UNITED STATES PATENT AND TRADEMARK OFFICE

09/875,619

Office Action Summary

DETAILED ACTION

FIG. 1

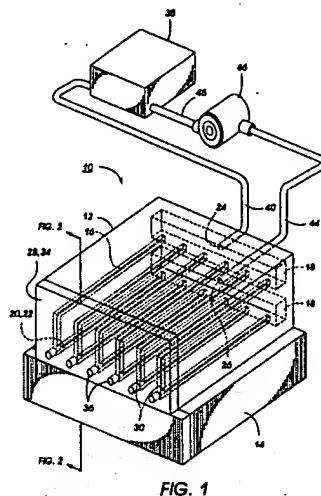
- {claim 1} Droplet deposition apparatus (figure 1); an array of fluid chambers (figure 1-2, reference 16), each chamber communicating with an orifice for droplet ejection, a common fluid inlet manifold (figure 1-2, reference 18; top) and a common fluid outlet manifold (figure 1-2, reference 18; bottom); each chamber so connected with the inlet manifold and the outlet manifold as to enable a fluid flow from the inlet manifold, through each chamber in the array and into the outlet manifold, the fluid flow through each chamber being sufficient to prevent foreign bodies in the fluid from lodging in the orifice (figure 1-2; abstract; column 1, line 35-column 2, line 38; column 3, lines 15-40); each chamber being associated with means for effecting droplet ejection from the orifice simultaneously with the fluid flow through the chamber (abstract; continuously re-circulating ink); wherein the resistance to flow of the inlet and

outlet manifolds is chosen such that a negative static pressure at the orifice of any chamber in the array due to the flow varies between any two chambers by an amount less than that which would give rise to significant differences in droplet ejection properties between the two chambers in the array (abstract; column 1, line 35-column 2, line 38; column 3, line 54-column 4, line 18)

FIG. 2

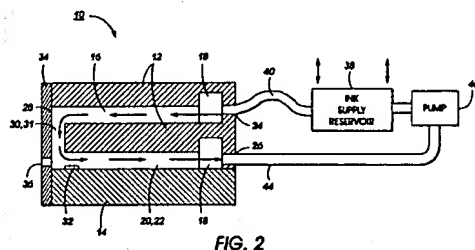
- {claim 2} wherein the inlet manifold has a resistance to flow less than that which would give rise to a variation in static pressure between the inlets to any two chambers in the array sufficient to produce significant differences in droplet ejection properties between the two chambers in the array (abstract; column 1, line 35-column 2, line 38; column 3, line 54-column 4, line 18)

- {claim 4} Droplet deposition apparatus (figure 1); an array of fluid chambers, each chamber communicating with an orifice for droplet ejection, a common fluid inlet manifold and a common fluid outlet manifold (figure 1-2, reference 16, 18); each chamber so connected with the inlet manifold and the outlet manifold as to enable a fluid flow from the inlet manifold, through each chamber in the array and into the outlet manifold, the fluid flow through each chamber being simultaneous with droplet ejection from the orifice and being sufficient to prevent foreign bodies in the fluid from lodging in the orifice (figure 1-2; abstract; column 1-2; column 3, lines 15-40); the resistance to flow of one of the inlet and outlet manifolds being chosen such that the pressure at a fluid inlet to any chamber in the array varies between any two chambers by an amount less than that which would give rise to significant differences in droplet ejection properties between the two chambers in the array (abstract; column 1-2; column 3, line 54-column 4, line 18)
